**FOLLOW-UP ON THE NASSRIYA
PRISON FACILITY
NASSRIYA, IRAQ**

**SIGIR PA-08-131
APRIL 17, 2008**

SUBJECT: Report on Project Assessment of the follow-Up on the Nassriya Prison
Facility, Nassriya, Iraq (Report Number SIGIR PA-08-131)

SUBJECT: Draft SIGIR Project Assessment Report – Follow-up on the Nassriya Prison Facility, Nassriya, Iraq, SIGIR Report Number PA- 08-131

Figure 4. Inmate housing design (Figure courtesy of the USACE)

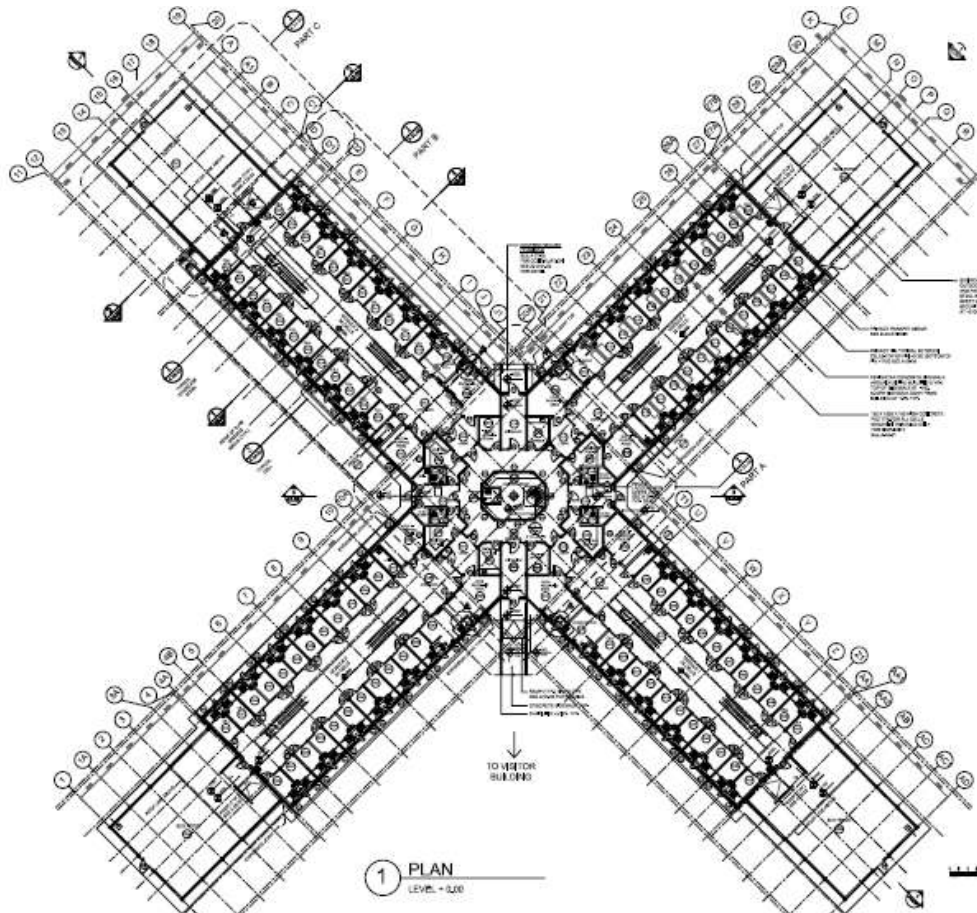
3. **Draft Report, Page 7 – last sentence and top of Page 8.** The four wings of each housing unit were designed to contain two floors of inmate cells with 24 cells per floor in each of the four wings for a total of 192 cells per building (Figure 4).

Command Comment. Change the sentence to read, ““The four wings of each housing unit were designed to contain two floors of inmate cells with 26 cells upstairs and 24 cells downstairs in each of the four wings for a total of 200 cells per building (Figure 4).”
